Exchange of propeller shaft on ROTAX® Engine type 912 / 914 (Series) and 912 i (Series)

ATA System: 72-10-00 Propeller gear assy.

MANDATORY

SERVICE BULLETIN

Fig. 1

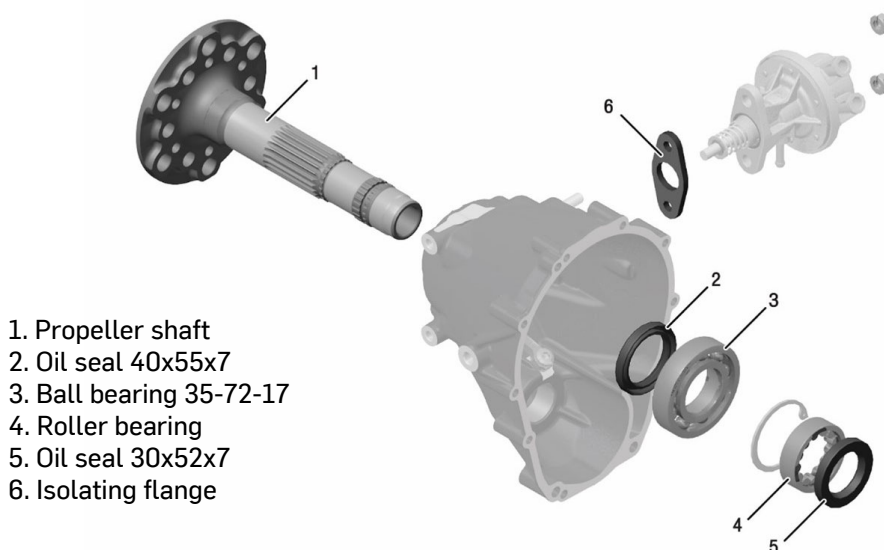
See Fig. 1.

Parts requirement in case of replacement:
